Access Compliance Report

Public Rights-of-Way

(Curb Ramps)

Intersection ID: 12329	Main Street: E_15TH_ST	Cross Street: PEGRAM_ST	Location:	N
ADA ID: 560FD801AB4A	Ramp Type: Perp	Initial Pass/Fail: Fail	Overall Compliance: No	Severity Score: 8.75
Codes/Mitigation Info/Possible Solution		Field Measurements/Component Compliance

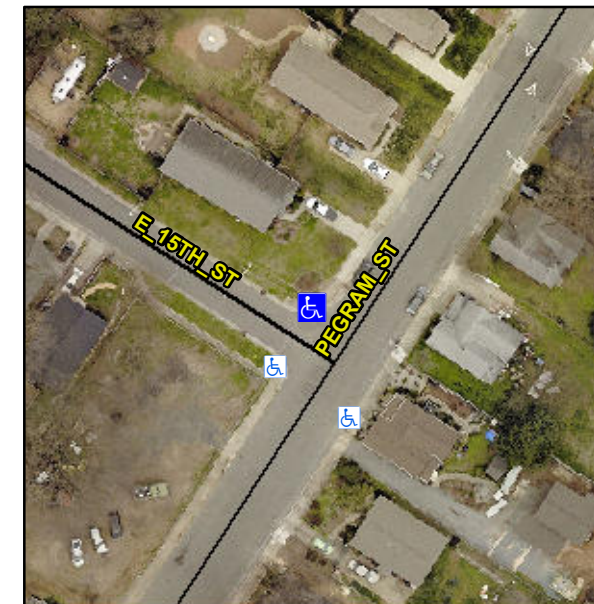
Not Found, R304.5.1

Compliance	Description	Data	Compliance	Description	Data
N/A	Ramp Length (in)	69.5	Yes	Ramp Slope (%)	7.5
No	Ramp Width (in)	39.0	Yes	Ramp XSlope (%)	1.9
N/A	Flare Type LT	N/A	N/A	Flare Type RT	N/A
N/A	Flare Slope LT (%)	N/A	N/A	Flare Slope RT (%)	N/A
N/A	Flare Traversable LT?	N/A	N/A	Flare Traversable RT?	N/A
N/A	Landing Length (in)	N/A	N/A	DWS Provided?	N/A
N/A	Landing Width (in)	N/A	N/A	DWS Contrast?	N/A
N/A	Landing Slope (%)	N/A	N/A	DWS Length (in)	N/A
N/A	Landing X Slope (%)	N/A	N/A	DWS Full Width?	N/A
N/A	Landing Curb? (Y/N)	N/A	N/A	DWS Offset (in)	N/A
N/A	Shared Landing?	N/A			
N/A	Gutter Ponding?	N/A	N/A	Gutter Slope (%)	N/A
N/A	Gutter Lip Ht (in)	N/A	N/A	Gutter X Slope (%)	N/A
N/A	Painted X Walk1?	No	N/A	Painted X Walk2?	N/A
	X Walk 1 Direction	To SW		X Walk 2 Direction	N/A
N/A	X Walk 1 Width (in)	N/A	N/A	X Walk 2 Width (in)	N/A
	X Walk 1 Slope (%)	2.4		X Walk 2 Slope (%)	N/A
	X Walk 1 X Slope (%)	1.2		X Walk 2 X Slope (%)	N/A

Remove & Replace Entire Ramp.
